To: Plan Holders for Improvements to the
Salina Regional Airport
Salina, Kansas
New Aviation Bulk Fuel Facility

Transmitted herewith is Addendum No. 3 to the Contract Documents, Plans, and Specifications dated April 17, 2023 for Improvements to the Salina Regional Airport, Salina, Kansas, New Aviation Bulk Fuel Facility.

**ADDENDUM NO. 3
TO
CONTRACT DOCUMENTS, SPECIFICATIONS AND PLANS
FOR IMPROVEMENTS TO THE
SALINA REGIONAL AIRPORT
SALINA, KANSAS
AIP NO. 3-20-0072-047/049**

E-700

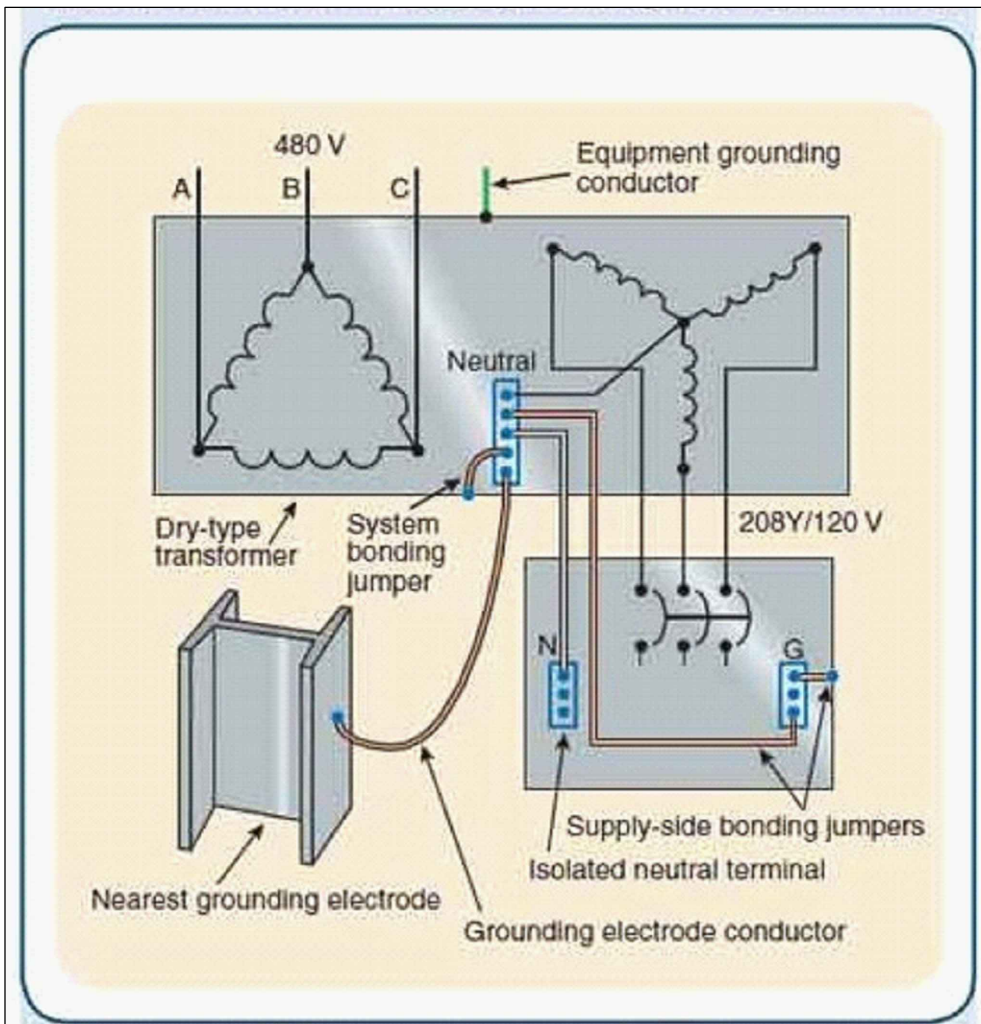
E-700 – Electrical Sheets – These sheets have been updated to show the recommended generator information in the one-line diagram.

Justification: This information was not previously included.
